SUBJECT: Amendment No. 2 to Bid 2021-024 *Communication Center Renovation*

BID TITLE: Communications Center Renovation

HCSO
YBOR CITY
NEW & REUSED ITEMS

DEMOLITION FLOOR PLAN

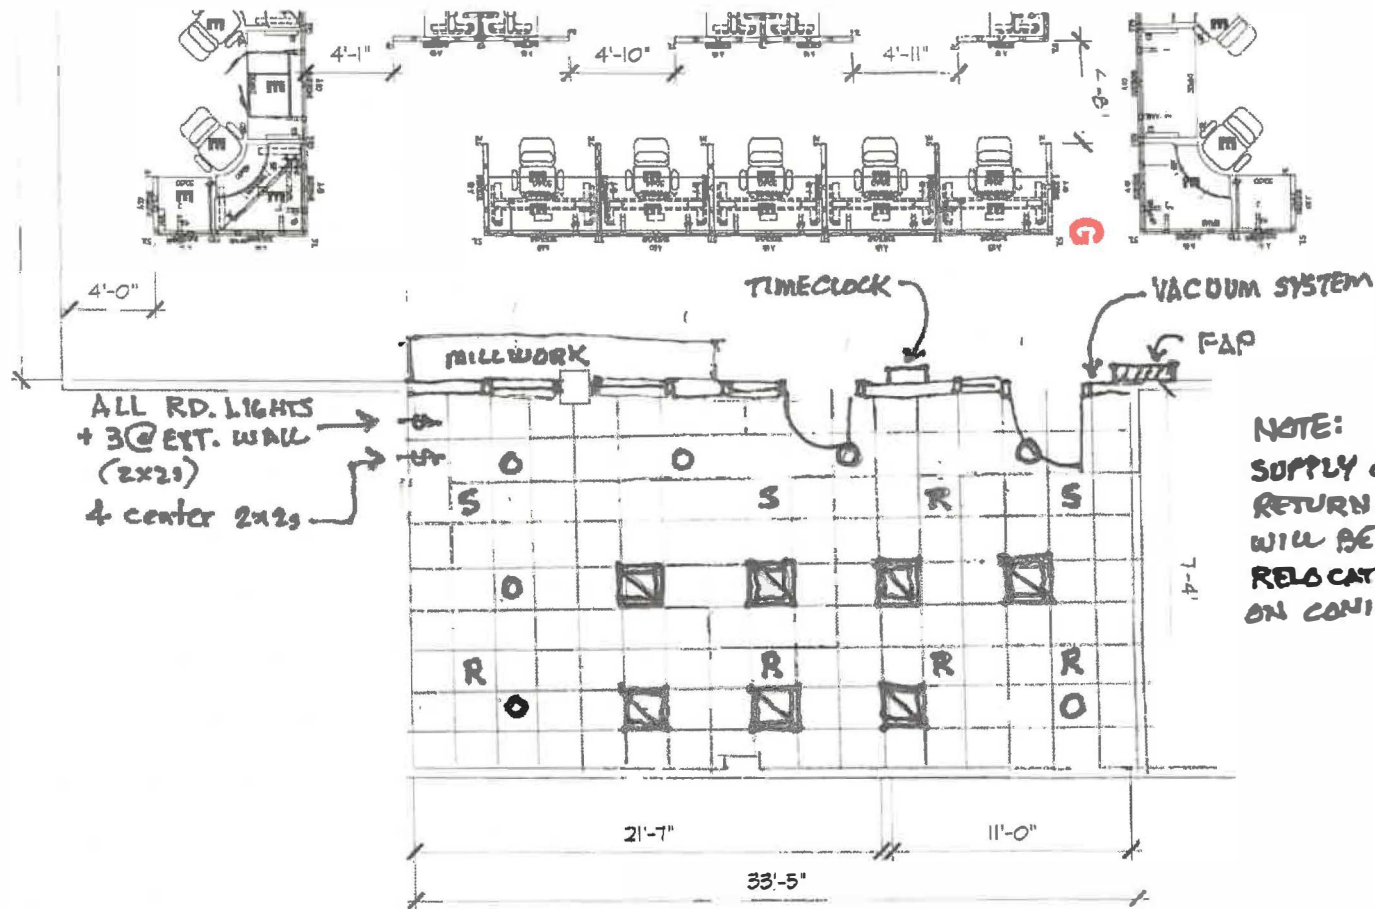
- a. Interior renovation for combining two offices into one larger room +/- 400 SF.
 - i. Demolition of wall on the long side of combined rooms as well as the wall currently separating the two rooms.

- ii. Demolished walls shall be removed down to concrete floor.
 - iii. Dispose of all interior window frames and glass.
 - iv. Segment of wall behind existing fire panel shall remain and wall end shall be drywall finished.

- v. Removed north wall will need header to accommodate different ceiling heights.
 - vi. Data boxes and cables to remain in place except at demolished walls wherein boxes have been removed and wiring left in place on concrete slab.

AL - This vent stack needs to be re-routed under & through raised floor horizontally; then up the remaining portion of the wall next to the door frame being removed and then reconnected overhead in the soffit area back to upper portion of vent stack.

NEW REFLECTED CEILING PLAN

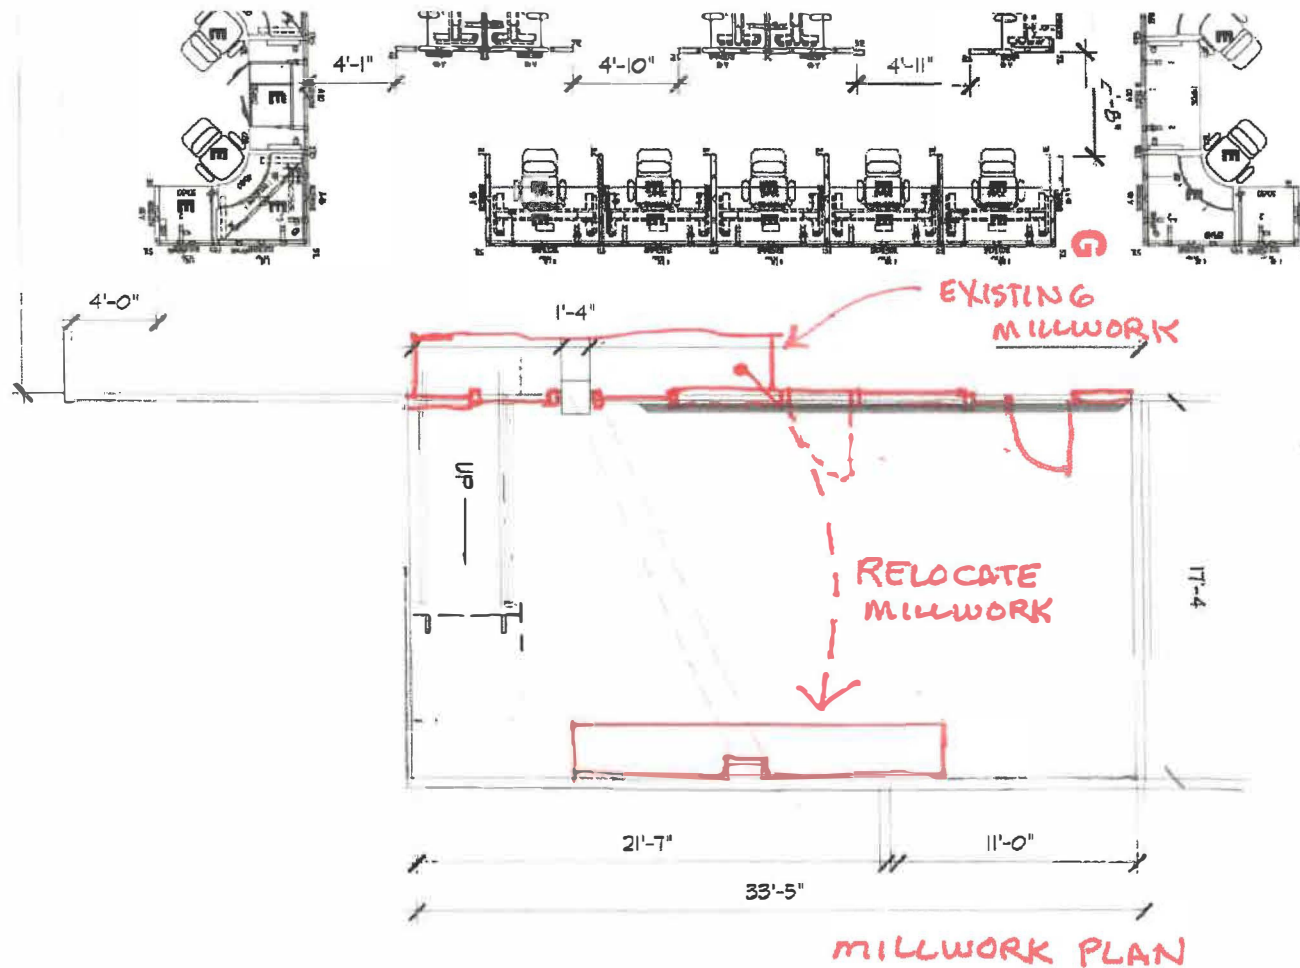
- ii. New round fixtures shall be Lithonia Lighting Model: WF6 LED 50K MVOLT MW M6 120-277V 60Hz 0.09A 10.5W 0-10 Dimmer.
 - iii. Lights shall be installed in accordance with the reflected ceiling plan contained in Attachment 1, Combined layout plans.

Notes from last visit and new revised reflected ceiling plan was distributed showing 2x2 instead of 2x4 lights and round LED light fixtures. New lighting shall be e-conolight C-TR-A-BT22_33L-50K-WH-4 (LED 2X2 Trfr, 3300L, 5000K, 120-277V, 0-10V Dimming, White, Damp Location, DLC Premium)

EXISTING SUPPLY DUCT CONDITION

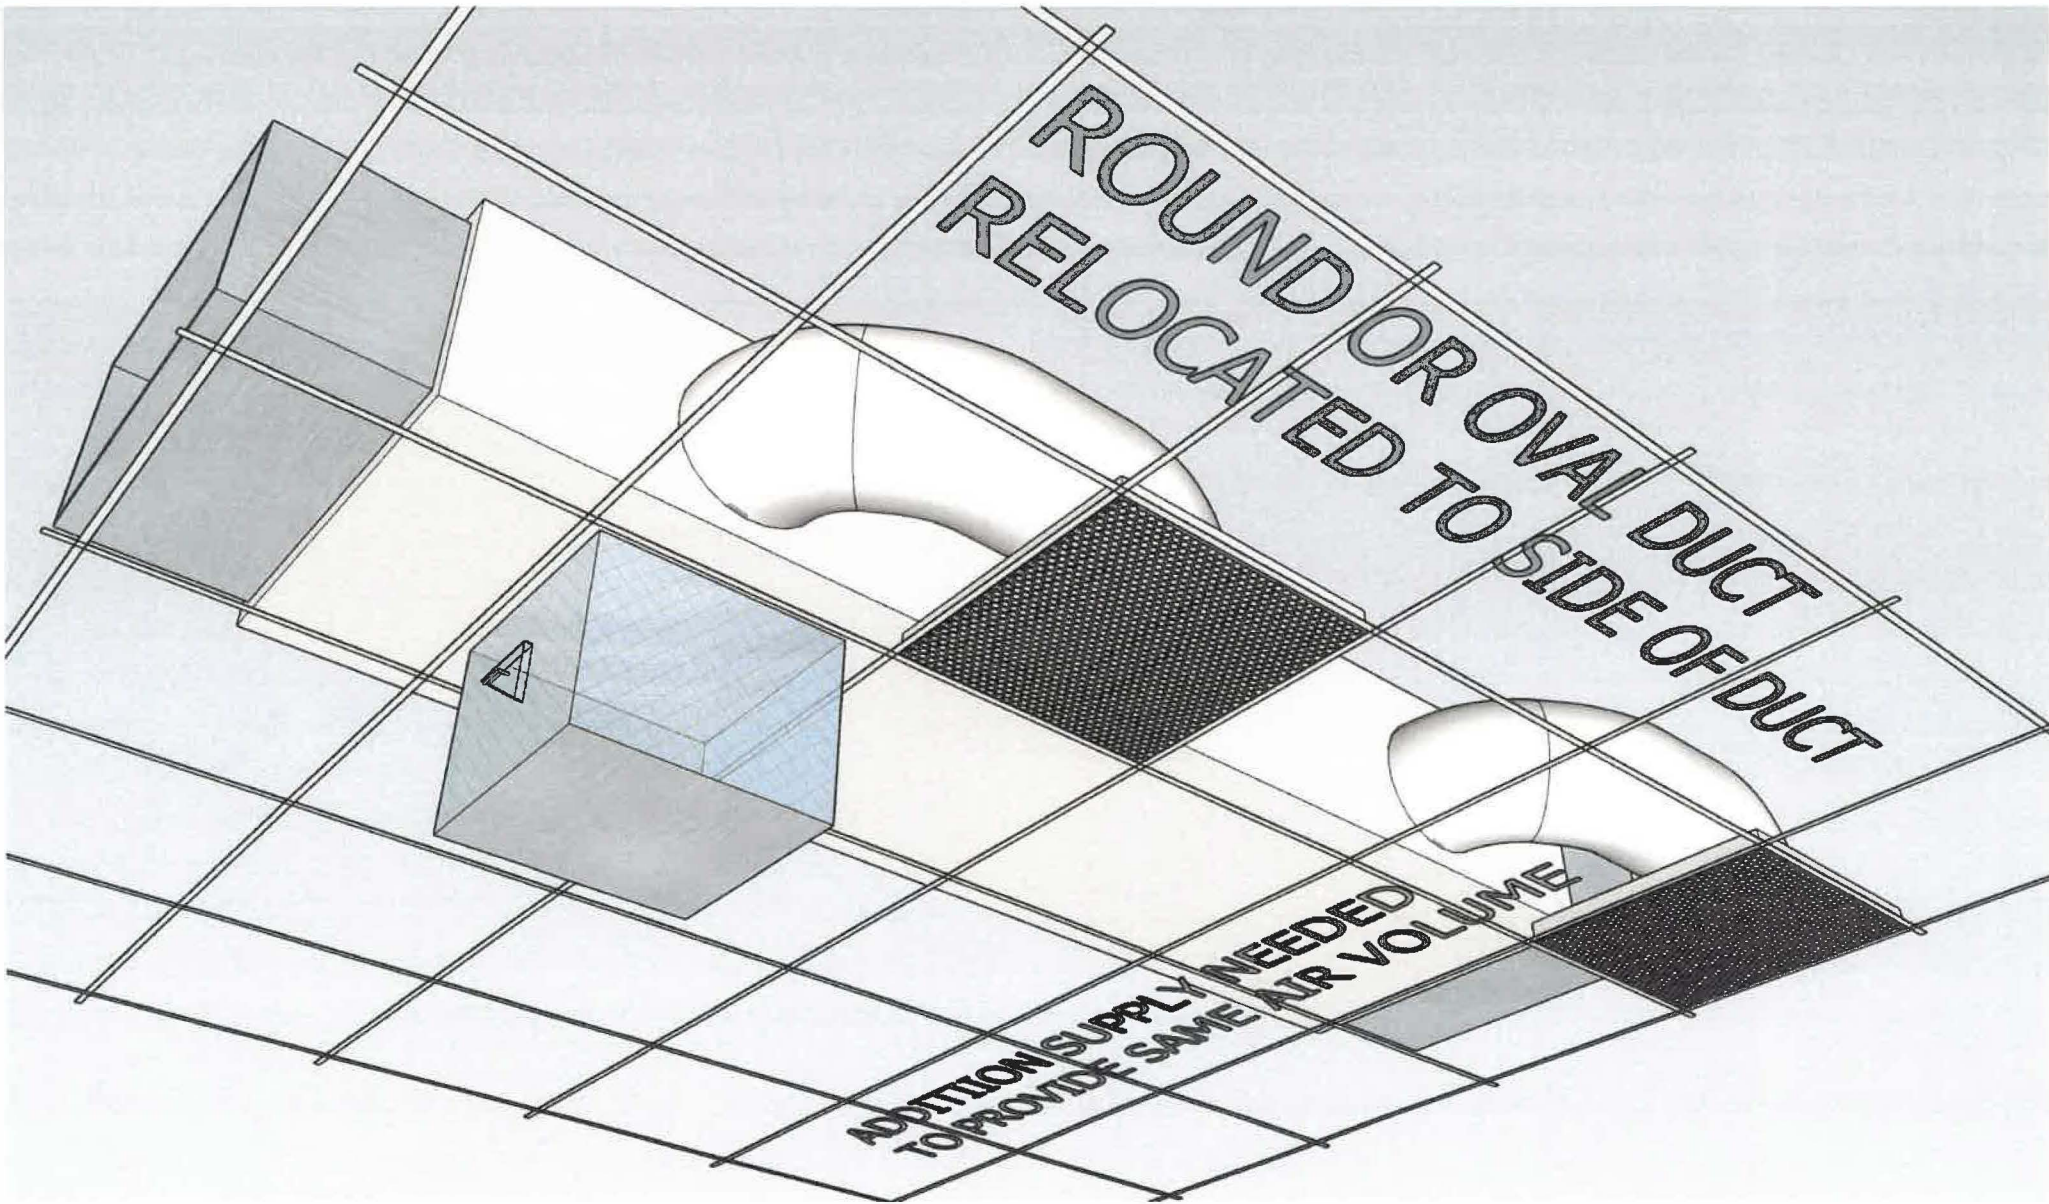
- i. Raise the ceiling to the underside of the ductwork allowing space to insert ceiling tiles – supply ducts must be relocated to side of duct trunk, see Attachment 2.

- iv. A/C supply registers may need to be added to accommodate the same air flow at the existing duct drops being removed, recommended round or oval flex.

ROUND OR OVAL DUCT
RELOCATED TO SIDE OF DUCT

ADDITION SUPPLY NEEDED
TO PROVIDE SAME AIR VOLUME
